COMMITTEE OF THE WHOLE JUNE 4, 2001

**SITE DEVELOPMENT APPLICATION
THE ITALIAN PENTECOSTAL CHURCH
FILE: DA.00.140**

ATTACHMENT "2" SITE PLAN	FILE #:	REPORT #:	DATE: 01/02/21
	DA.00.140	LOCATION: LOT 8, CONC. 5	SCALE: NOT TO SCALE
		CITY OF WAUGHAN PLANNING DEPARTMENT	APPLICANT: THE ITALIAN PENTECOSTAL CHURCH INC. (NEW LET. CUMMERTON, MISSISSAUGA)

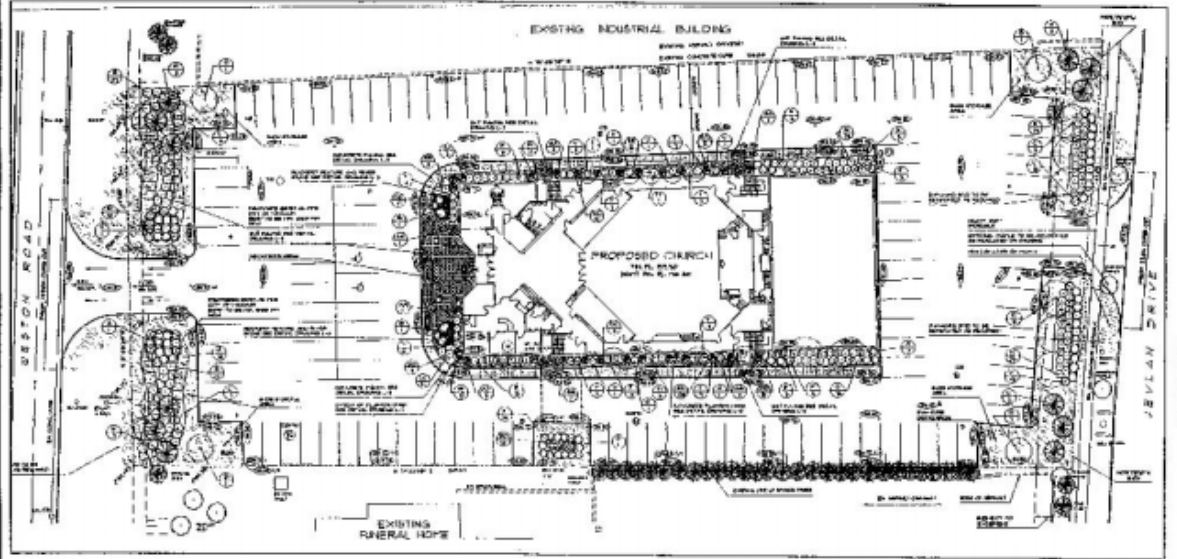
The rectangular-shaped lot has been sited with the proposed church in the center, facing Weston Road, and surrounded by parking. Access to and from the site is proposed by a right-in/right-out access from Weston Road and a full access from Jevlan Drive. A 9.0 m landscape strip has been provided along Weston Road and a 6.0 m landscape strip along Jevlan Drive. The site statistics are as follows:

The proposed site plan identifies two accesses. The Jevlan Drive access is a full service ingress/egress driveway, and is subject to the approval of Vaughan Engineering.

The right-in/right-out access to Weston Road, has been approved by York Region, subject to the following comment:

“A reference plan is required for lifting the 0.3 metre reserve to provide access to the site. The length of reserve to be lifted is from the edge to edge of pavement of the as-constructed driveway plus 500 mm beyond each edge of driveway.

By-law 1-88 requires 116 parking spaces whereas the site plan proposes 128. Concerns have arisen regarding parking availability during peak service hours. Therefore, in-lieu of a mandatory parking supply study, Transportation Staff have requested that the Applicant provide a letter of understanding that an abutting-neighbour parking relationship has been established with the Delmoro Funeral Home to the south at 8101 Weston Road. The applicant has entered into discussions regarding this matter with the Owner of the property to the south.

- a. That prior to the execution of the site plan agreement:
 - i) the final site plan and building elevations, including any signage, shall be approved by the Community Planning and Urban Design Departments;
 - ii) the final landscape plan and detailed landscape cost estimate shall be approved by the Urban Design Department;
 - iii) the final site grading and servicing plans and stormwater management report shall be approved by the Engineering Department;
 - iv) parking, access and on-site vehicular circulation shall be approved by the Engineering Department;
 - v) all hydro requirements shall be fulfilled to the satisfaction of Hydro Vaughan Distribution; and
 - vi) should any variances be required to implement the proposed and approved site plan be final and binding.

ATTACHMENT "3" LANDSCAPE PLAN	FILE #:	REPORT #:	DATE: 01/02/21
	EA.00.140	LOCATION: LOT B, CONC. 5	SCALE: NOT TO SCALE
		CITY OF VAUGHAN PLANNING DEPARTMENT	APPLICANT: THE ITALIAN PENTECOSTAL CHURCH INC. (NEW LIFE CHRISTIAN CHURCH)

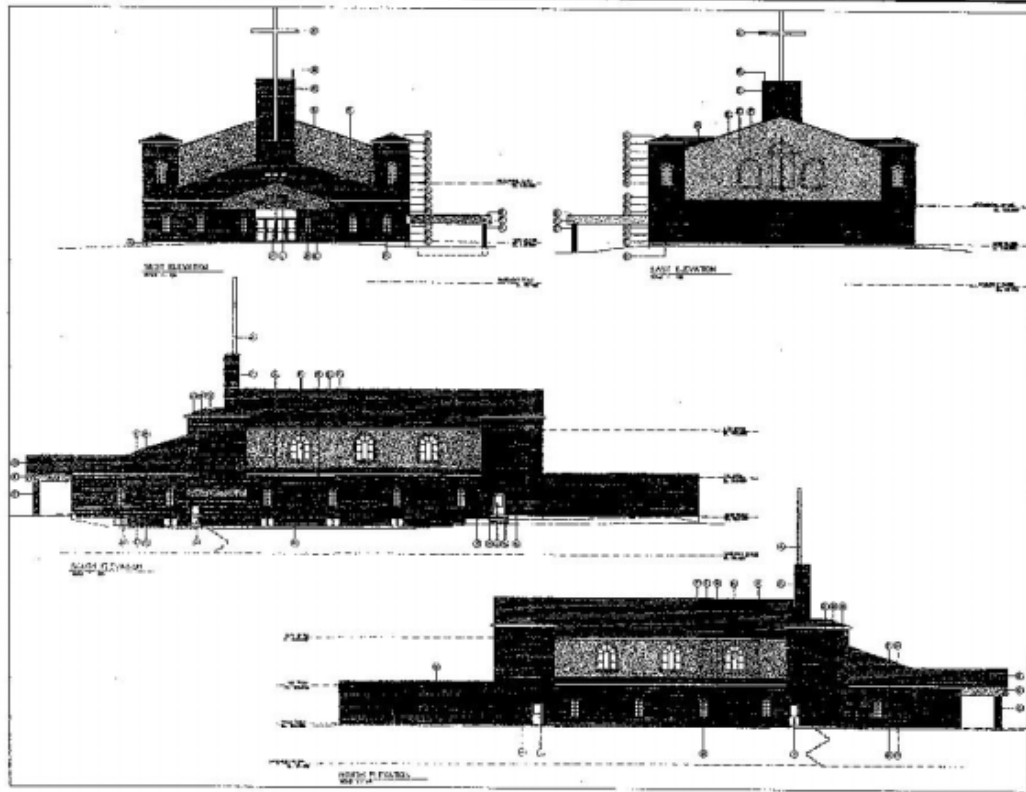
Extensive landscaping is proposed along both Weston Road and Jevlan Drive, including a mix of deciduous and coniferous tree planting. Landscaping has also been proposed in front of the church and along the two sides. The final landscaping plan is subject to the approval of the Urban Design Department.
